Indoor Station Firmware V2.2.22_build230718

Release Note (2023-07-20)

Device Model	DS-KH6320-WTDE1, DS-KH6320-TDE1
Firmware Version	V2.2.22_build230718
iVMS-4200	V3.10.0.5 or later

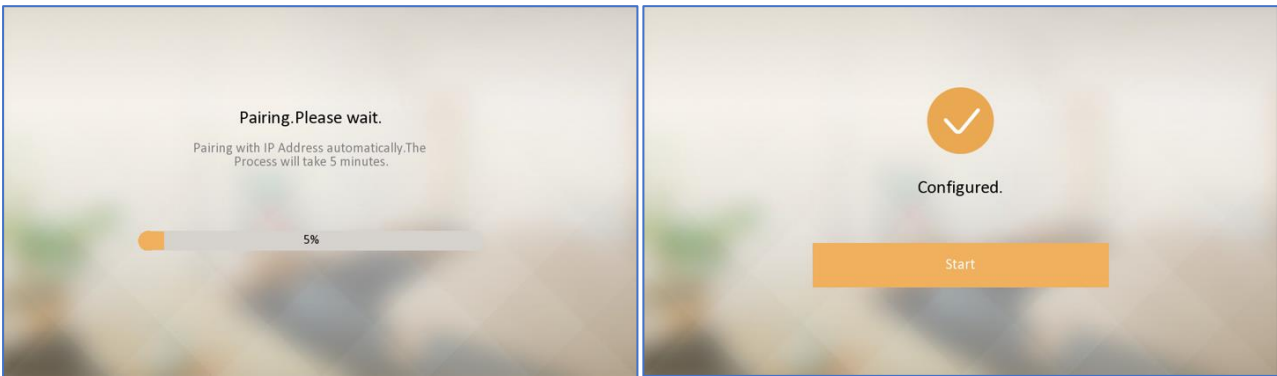
D. Pairing with main door station, sub door station and indoor extension

Note: The pairing time duration depends on the device quantity you selected in previous steps, it will take about up to 5 mins, please wait patiently until the process finish and show “Configured” as below.

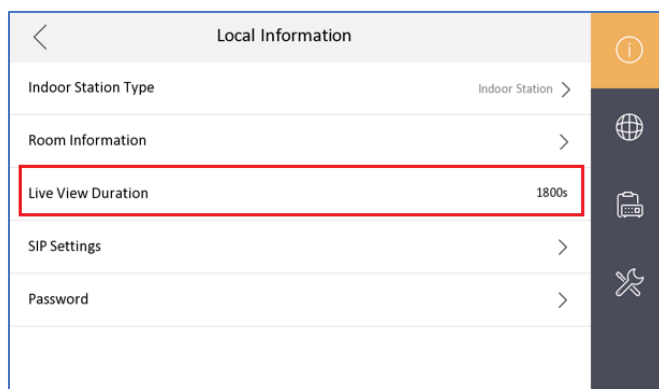
1. Optimized the icon of door station registration status in the main UI up right corner.

Note: If the door station call indoor station failed, you can click this icon  to register to door station manually, if register failed, it will indicate the reason for the failure.

Before	Now
Indoor station registers to door station success		
Indoor station registers to door station failed		
Indoor station registers to door station and KM9503 success

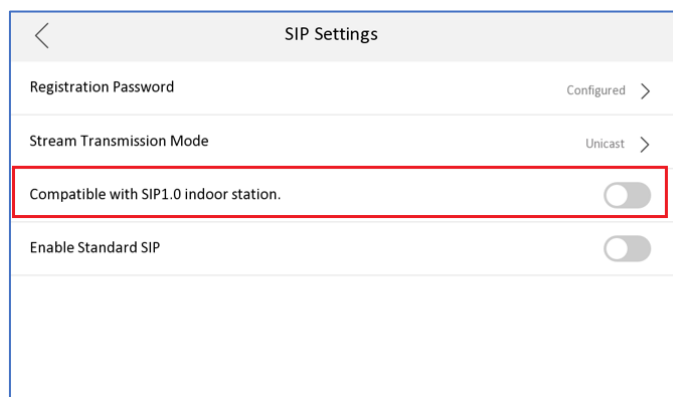
3. Support switching between protocol 1.0 and 2.0, by default it's protocol 2.0
After enable, the indoor station is compatible with protocol 1.0 indoor extension and not

compatible with protocol 2.0 indoor extension.

Note: After enable, all indoor extension of this indoor station must be protocol 1.0 firmware, don't mix protocol 1.0 and 2.0 indoor extension under same indoor station, or it will result to calling failed.

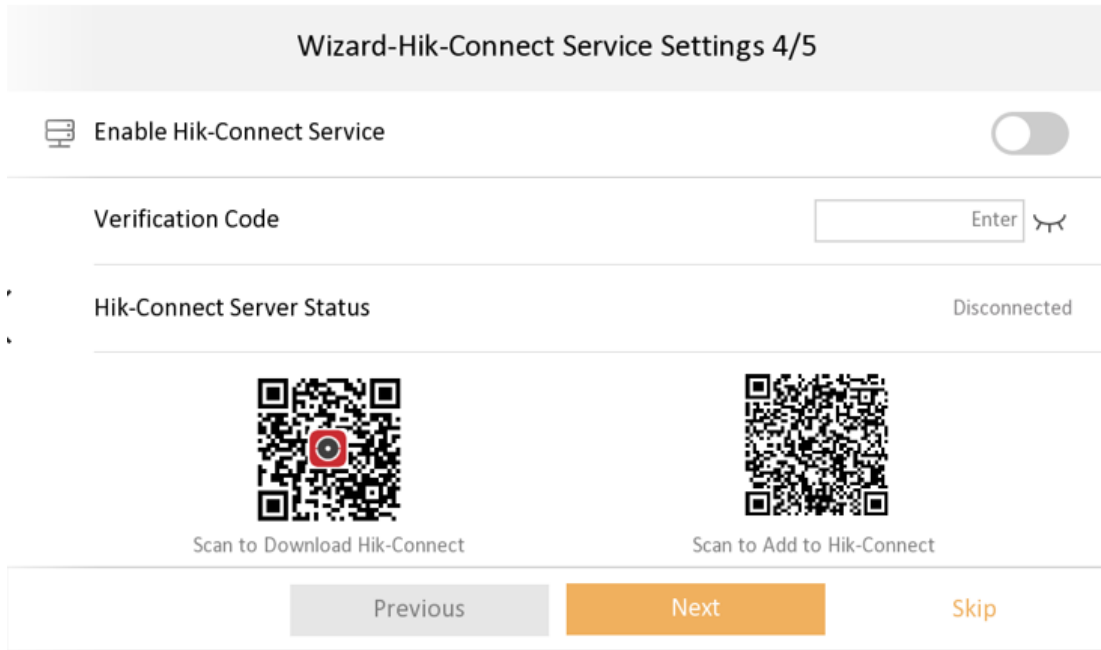
1. Optimize registration password settings in Wizard.

When enabled, the people who has the registration password will have the device admin permissions.

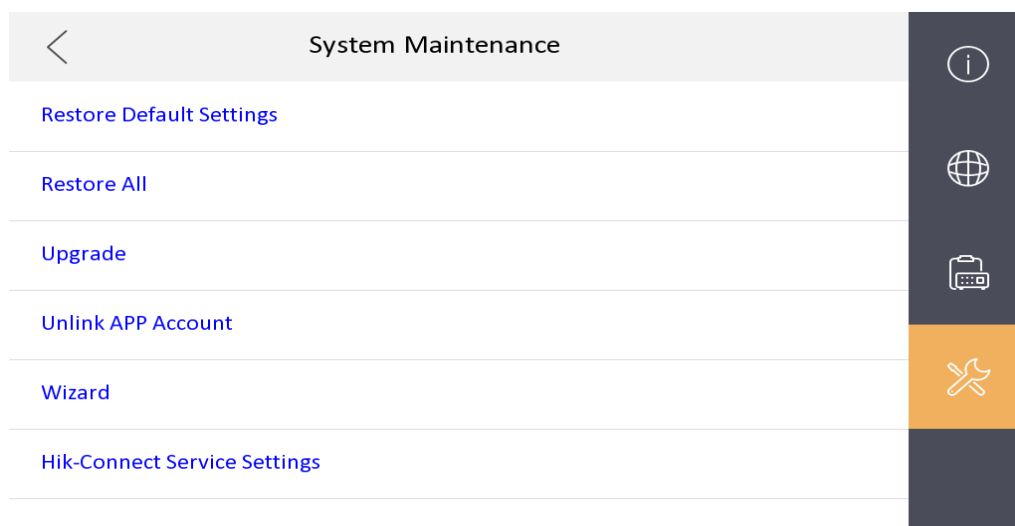
1. Verification code is empty by default.

- Hik-Connect Service Settings is changed to the place of Settings→ Advanced Settings→ Configuration→ System Maintenance.

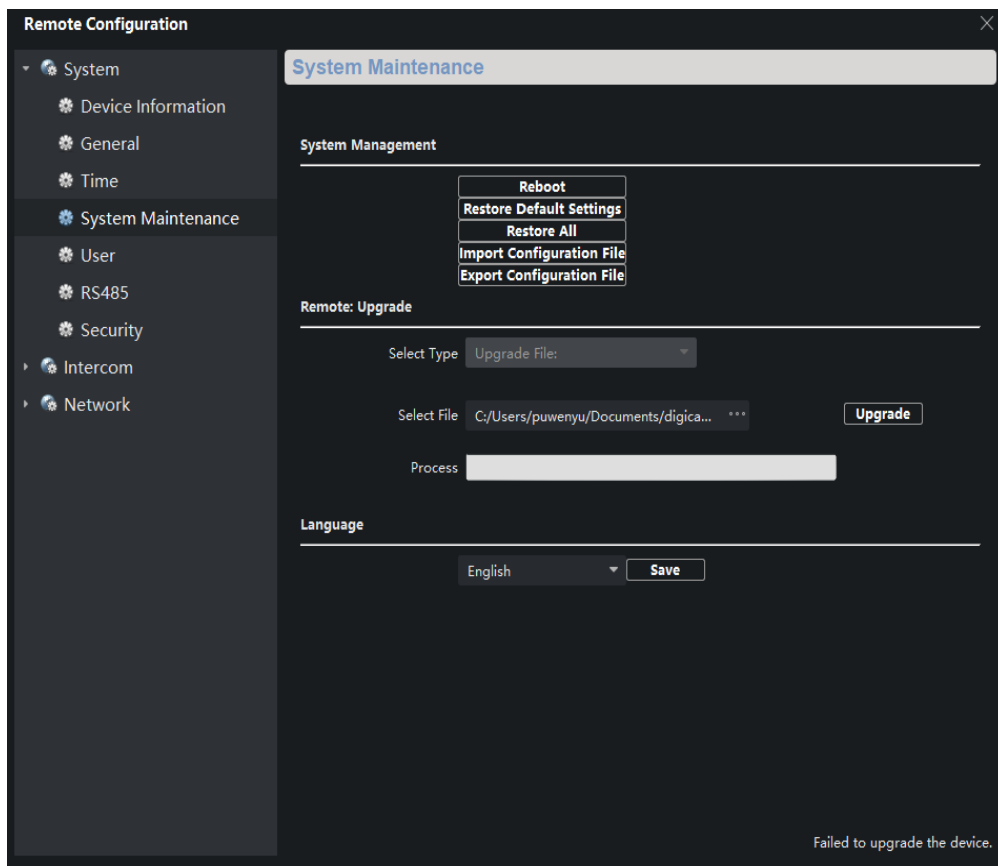
- Since **V2.1.24 build 210617**, remote

degradation of devices is not supported in all subsequent versions. When degradation occurs, it will prompt Failed to upgrade the device and the device will restart.

Notice: Although the device can be degraded by serial port, the device will fail to start and cannot change the version by using serial port again, which means that the device will be completely unusable.

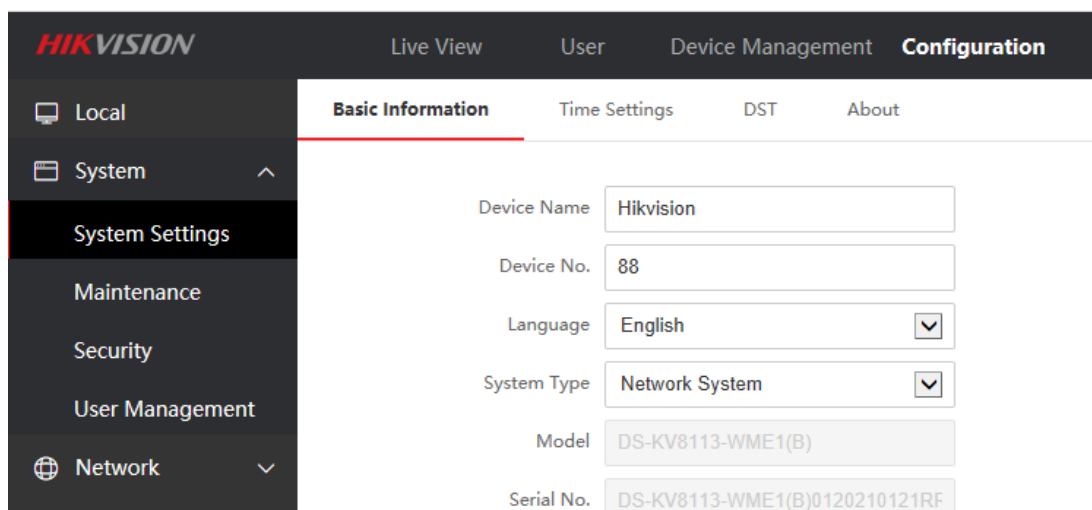
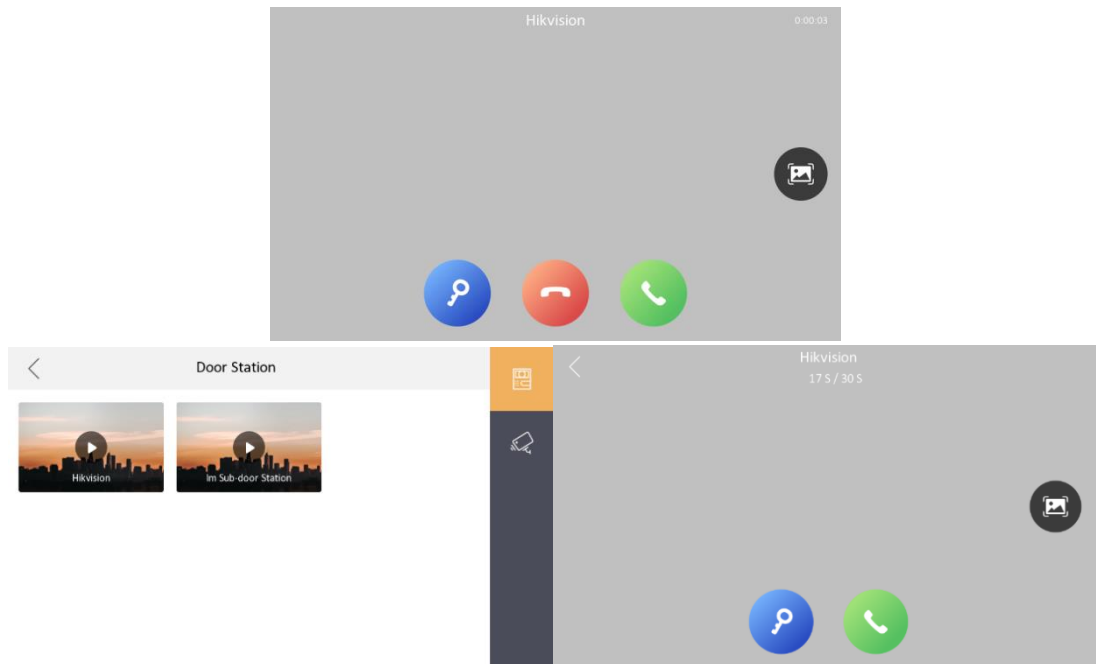
1. Change the position of unlock password and duress code, to enter the password page requires an admin (activation) password.

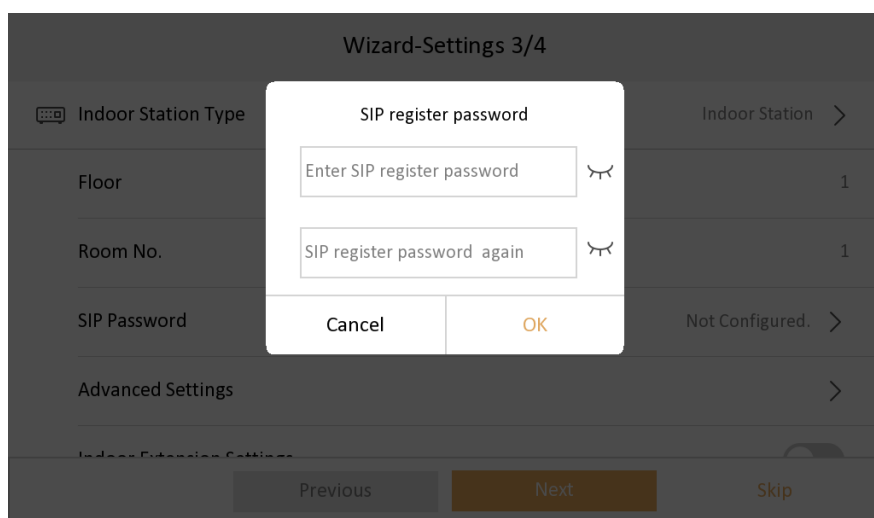
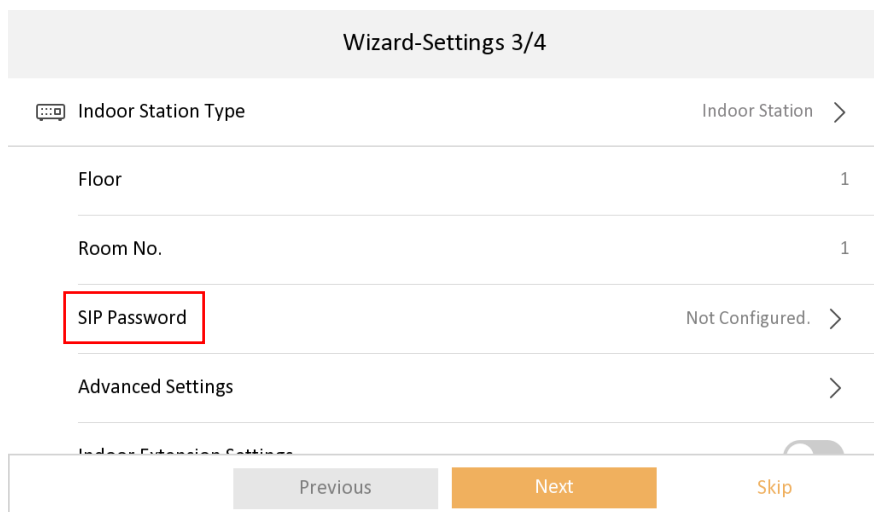
1. Higher security, SIP Passwords

SIP password is actually Register Password, which is suitable for our security 2.0 protocol. They can communicate normally only when the **SIP passwords (Register passwords)** of the door station, indoor station and indoor extension are the **same**.
